# Ashington Parish Council

**Ref: Planning application -**

**DC/23/0406 - Land To The West of Ashington C of E School**

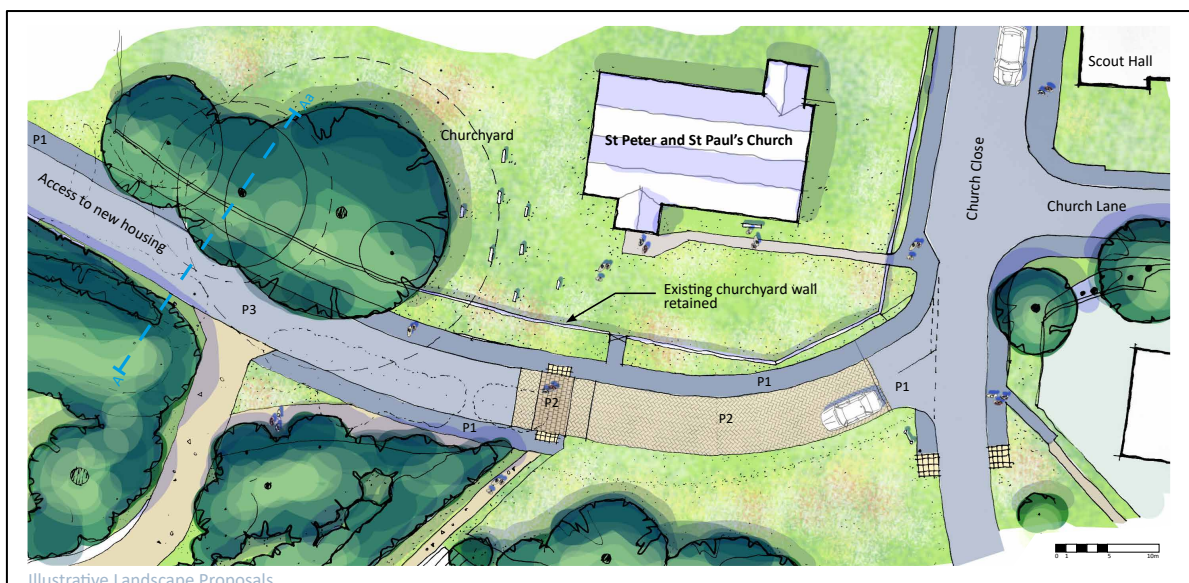
As this area is prone to flooding, and the topography would indicate that any excess water would be likely to run down into the development rather than away from it, we would seek clarification as to whether this matter has been addressed?

There is concern about the noise and vibration from the “rumbled block paving” so close to the church wall. As a “no dig construction” method has been proposed, we assume that by default this will necessitate a raised “speed table” type section, again that could cause noise and vibration as already happens with other roads in the village?

If the developers had amended the junction to match the previously requested staggered junction as per the ANP and WSCC Highways, this would also have moved the proximity of the road farther away from the church wall. To do this would require purchase of a small section of parish council land, and we can confirm we have not been formally approached in this respect.

Unfortunately, there was an error on the original drawing which showed the land falling in the wrong direction. Drawing No. BEL-SL-SITE SECTION 01 is now submitted which shows that the site will fall from the south to the north.

Concerns about the impact of the proposed development on the listed Church has also be raised by consultees. To help demonstrate how the site access has been carefully designed to limit the impact on the setting of the church, an annotated coloured layout of the access has provided and a CGI image of the proposed development. This illustrates the proposed treatment of the access route, the retention of historic features such as the church wall and mature trees and a sensitively designed material palette. The annotated layout plan highlights that a no dig construction method would be used to ensure existing trees are not adversely impacted.

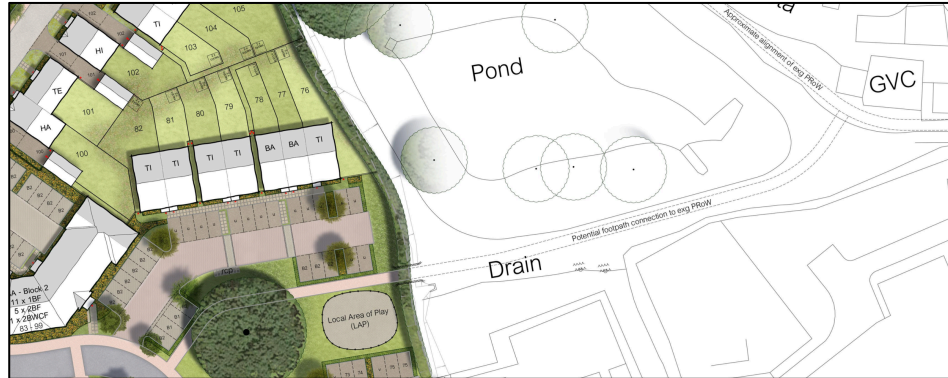
We note the new pedestrian connection proposed, although this has not previously been raised with the parish council despite running across our land. This footpath, if built to bridleway status as per the proposal for the rest of FP2607, will be exceedingly close to the pond and could be cause for concern, particularly given its proximity to the proposed play area.

We note that a footpath connection has been removed from the southern part of the development which appears to effectively remove footpath access to the Forest Schools area and to the MUGA. It appears that children will be required to walk alongside the road rather than through a safer non road route. No reason or rationale has been provided as to why this important footpath has been removed?

To improve the pedestrian connections across the site and to the surrounding footpath network, the applicant is proposing a new connection to the east of the site. Between the site boundary and Public Right of Way FP2607, the new connection would make use of an informal path in Parish Council controlled land, before entering the site by the proposed Local Area for Play.
